Access Compliance Report

Public Rights-of-Way

Intersection ID: 14714	Main Street: E_MOREHEAD_ST	Cross Street: HARDING_PL	Location: N
ADA ID: 1C78F4DB8891	Ramp Type: PerpDiag	Initial Pass/Fail: Fail	Overall Compliance: No
			Severity Score: 13.75

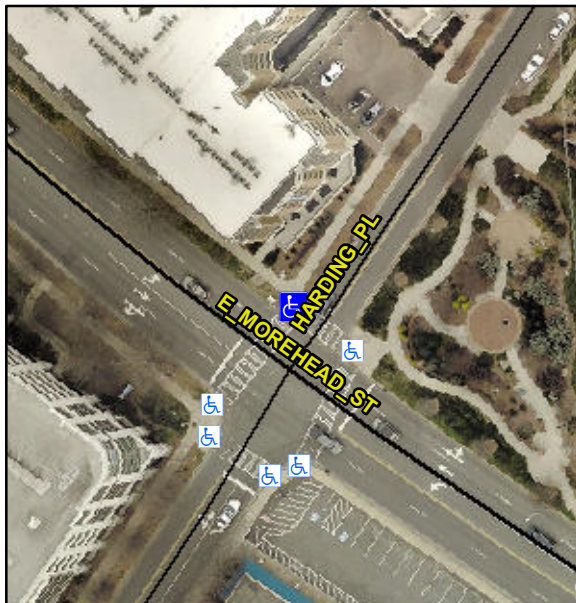
Not Found, R304.2.2

Compliance	Description	Data	Compliance	Description	Data
N/A	Ramp Length (in)	96.0	No	Ramp Slope (%)	8.5
Yes	Ramp Width (in)	48.0	Yes	Ramp XSlope (%)	2.7
N/A	Flare Type LT	N/A	N/A	Flare Type RT	N/A
N/A	Flare Slope LT (%)	N/A	N/A	Flare Slope RT (%)	N/A
N/A	Flare Traversable LT?	N/A	N/A	Flare Traversable RT?	N/A
N/A	Landing Length (in)	N/A	N/A	DWS Provided?	N/A
N/A	Landing Width (in)	N/A	N/A	DWS Contrast?	N/A
N/A	Landing Slope (%)	N/A	N/A	DWS Length (in)	N/A
N/A	Landing X Slope (%)	N/A	N/A	DWS Full Width?	N/A
N/A	Landing Curb? (Y/N)	N/A	N/A	DWS Offset (in)	N/A
N/A	Shared Landing?	N/A			
N/A	Gutter Ponding?	N/A	N/A	Gutter Slope (%)	N/A
N/A	Gutter Lip Ht (in)	N/A	N/A	Gutter X Slope (%)	N/A
N/A	Painted X Walk1?	Yes	N/A	Painted X Walk2?	Yes
	X Walk 1 Direction	To SW		X Walk 2 Direction	To SE
N/A	X Walk 1 Width (in)	108.0	N/A	X Walk 2 Width (in)	114.0
	X Walk 1 Slope (%)	3.5		X Walk 2 Slope (%)	0.5
	X Walk 1 X Slope (%)	2.7		X Walk 2 X Slope (%)	1.0

Remove & Replace Curb Ramp With Two New Directional Ramps or Equivalent.
